UNITED STATES PATENT AND TRADEMARK OFFICE

| APPLICATION NO. | FILING DATE | FIRST NAMED INVENTOR | ATTORNEY DOCKET NO. | CONFIRMATION NO. |
|-----------------|-------------|----------------------|---------------------|------------------|
| 10/646,833 | 08/25/2003 | Sang Van Tran | 1875.4810001 | 1356 |

| Office Action Summary | Application No. 10/646,833 | Applicant(s) TRAN ET AL. | |

DETAILED ACTION

Figure 7. AC-link Connections

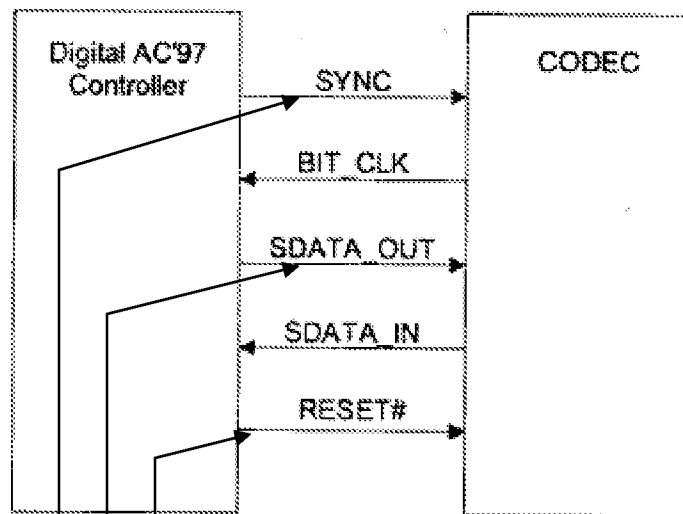
In response to applicant argument, applicant erroneously **assuming** and arguing the incorrect facts in CS4205. The following detailed examiner assertions.

RESET is optional – not use for transmitting audio- only used for transmitting of commands (see CS4205 page 13, section 2.1)

SDATA_OUT is a **FIRST SIGNAL LINE** that transmit audio information segments

SYNC is a **SECOND SIGNAL LINE** that transmits a number of synchronization markers

In view of the CS4205 FIG. above, it is clear that ONLY a first signal line and a second signal line are used for transmitting communication audio information segments. Also, one skilled in the ordinary would clearly see that RESET signal line is only for commands, and it is not used in communication audio.
